Cleveland Landmarks Commission

Thursday, February 11, 2021

Case 21-003: Little Italy Historic District (Concept Plan 1-14-2021)

Renovation for Washington Inn Studios

Before & After Photos

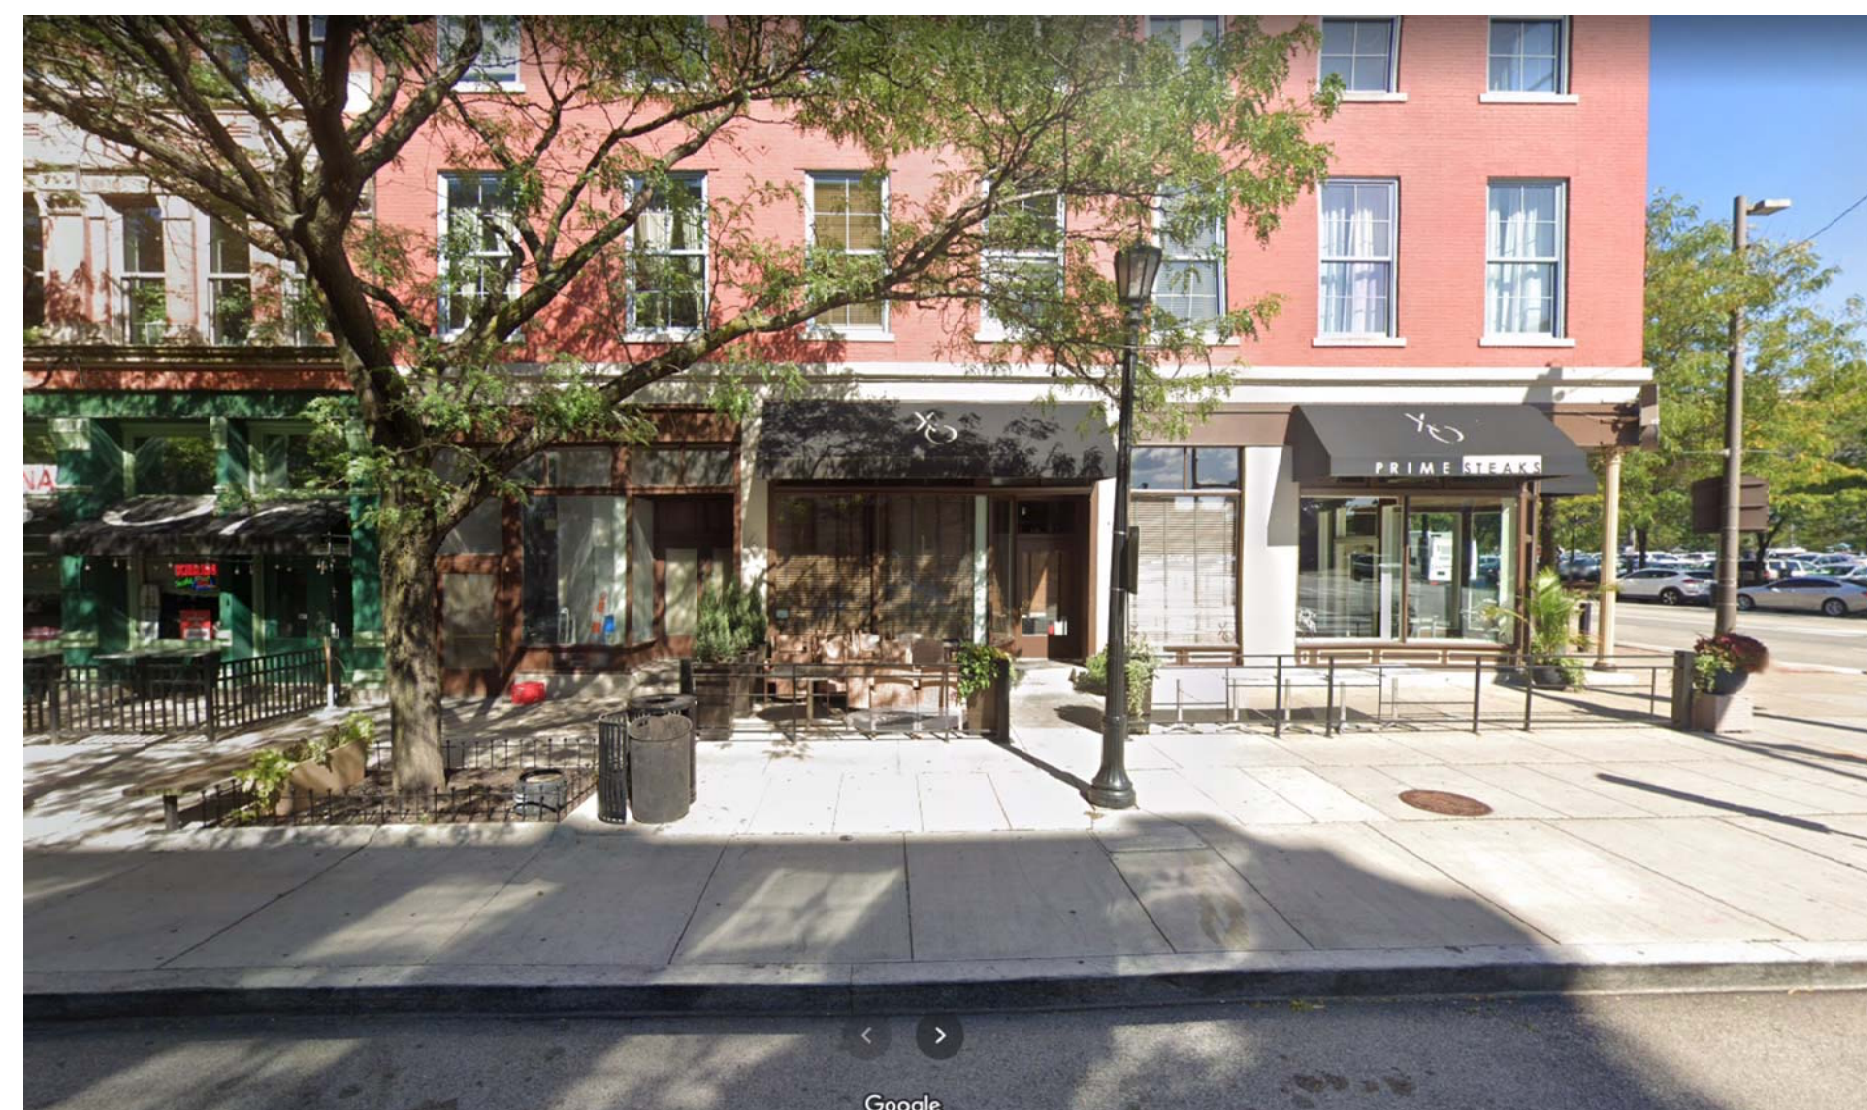
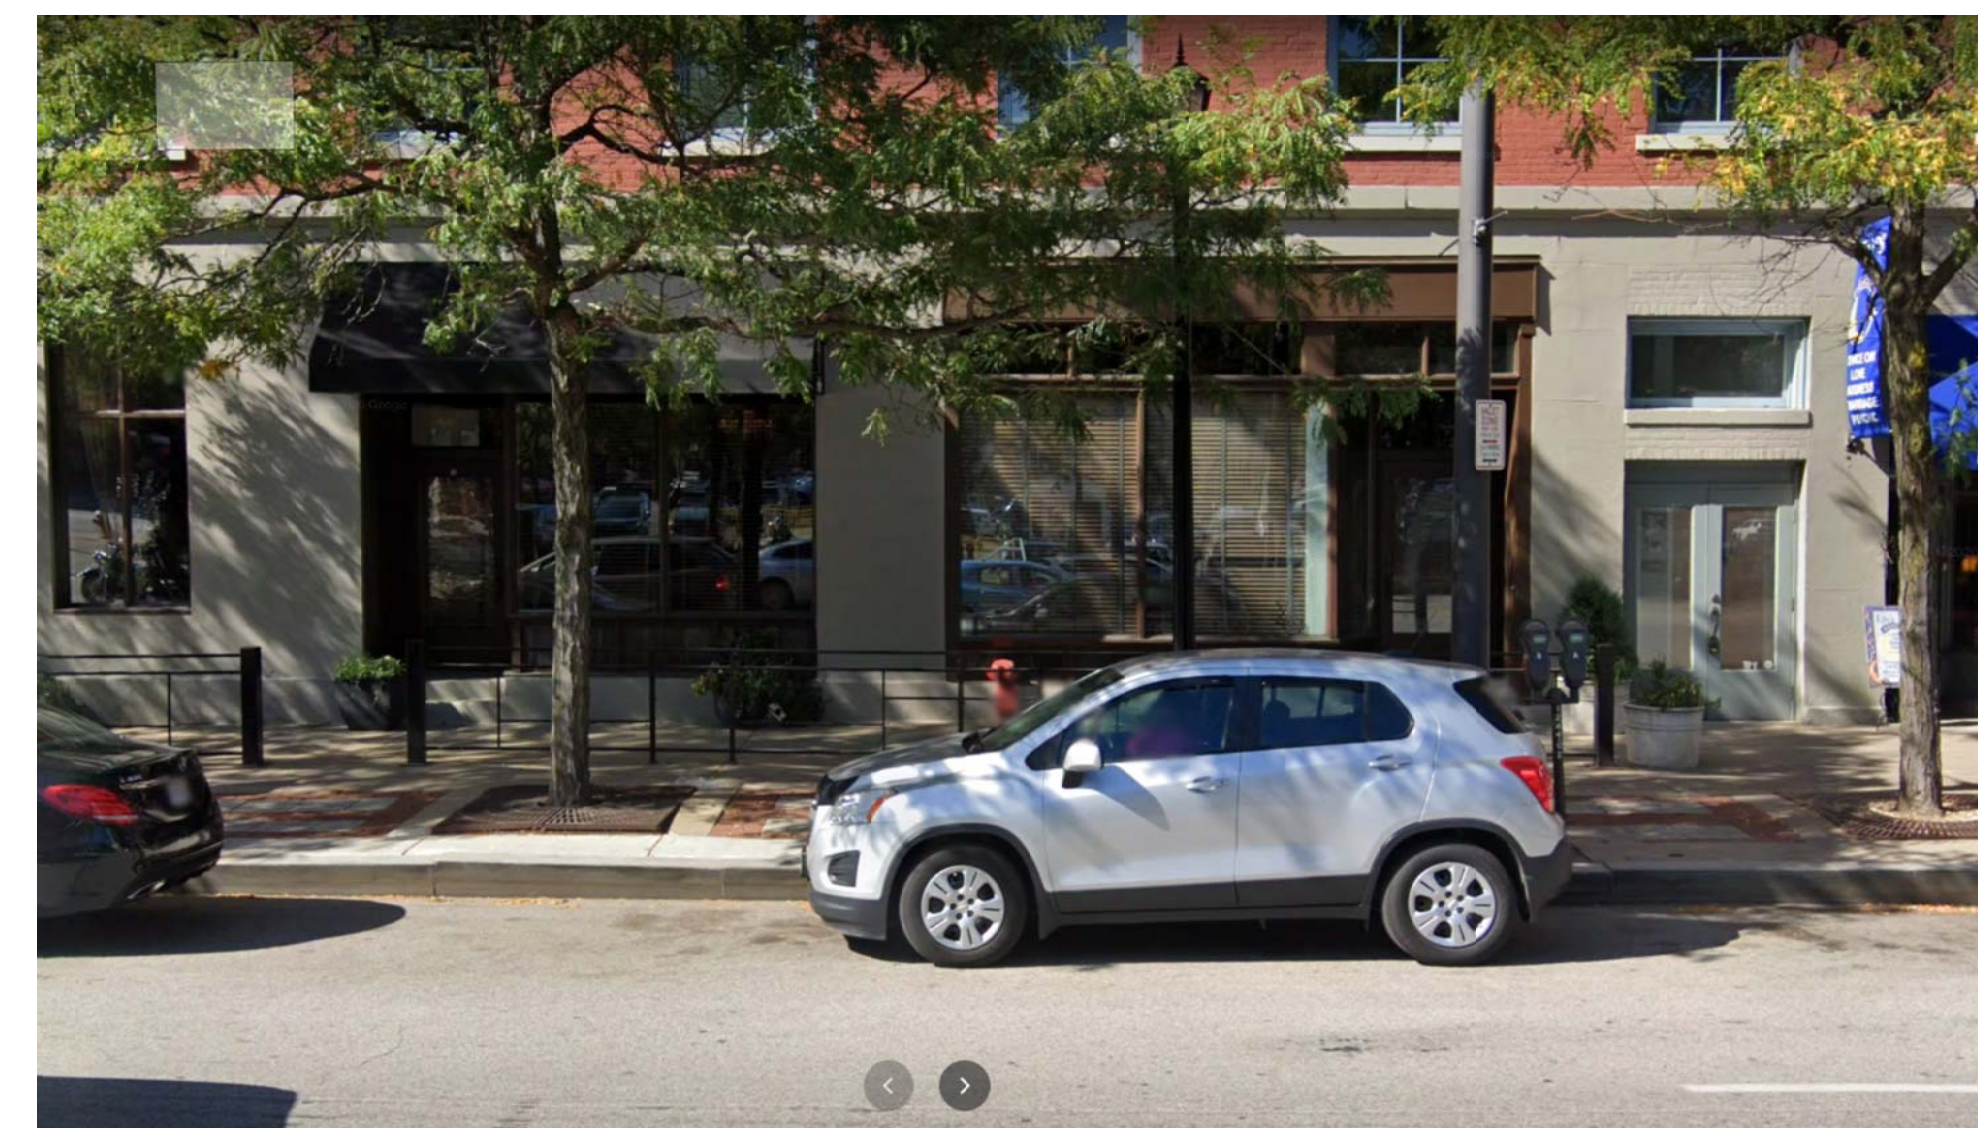
Canopy, operable storefront, new corner door, new entrance door.

- Outdoor patio and canopy with minimal pitch. Top glazing
- Light fixtures under canopy
- Move the main entrance to St. Clair to an existing storefront entrance
- Activate the corner door with new operable storefront - Nano wall system

- NZ - does not impinge on the building
- MB - glass - how to keep clean. Lola - plan to clean every two weeks
- AO - water on to the side walk a potential issue
- AO - light fixture - wind blowing them around
- AO - corner entrance - why? Prime seating
- RP - new main entrance seems tight
- RP - I like the design
- MB - in favor - sensitive - reversible
- AO - low profile - appropriate for this building
- DL - ok on precedent - others denied before can now come back with new proposal

- Canopy at corner no longer radiused - now a right angle
- Steel structure - primed and painted black
- Top glazed on top - transparent with a slight tint
- Café railing incorporated into the post
- Power for lighting accessed through one J-Box
- Lighting will be supported with bracing to guard against the wind
- Each post will include a footer

- Simulated bulk head to match adjacent existing storefront configuration
- All aluminum system including door

- 7'8" aluminum door at St Clair locations; size as existing at W 6th locations
- Painted black - not anodized
- Existing wood storefront will be painted black to match
- Remove existing concrete step for barrier free entrance - floor is lowered inside.
Remaining concrete repaired and finished

- Discussion on the finish on the canopy structure - concern to make the finish as durable as possible given that it is steel. Consider galvanizing for long term maintenance.
- Following clarifying questions, the following motion was made.

Change the configuration of the entries from recessed doorways to either a doorway that is flush with the façade or replaced with storefront.

- Doors and transom above the door to be aluminum as previously approved
- Where the doorway will not be used, it will be replaced with wood storefront to match existing including molding profiles, dimensions, and bulkheads with glass
- One doorway along W. 6th will remain recessed with steps with a new aluminum door

- Discussion on keep the glass in the bulkhead - it was agreed to keep the glass. Further agreed to meet on site to discuss keeping existing glass or replace with all new glass or a combination
- On the norther most doorway on W. 6th, there was discussion on the pattern of the bulkhead glass on the new section of glass that will replace the doorway. It was agreed to keep the existing section would remain and the new section would use a pattern as typical to the rest of the storefronts.
- Discussion on the columns directly behind the storefront glass in some areas - agreed to simply paint black to match storefront.

The Committee met consensus on approving the proposal conceptually despite not meeting the current guidelines. The applicant will meet with the Committee for a final review with refinements and further detail on 12/22. The Committee will refine the current guidelines on awnings and canopies and review and approve accordingly before the final review of this proposal.

Motion: Zarnas approved as presented.

With the agreed upon revisions in the above discussion, the following motion was made.
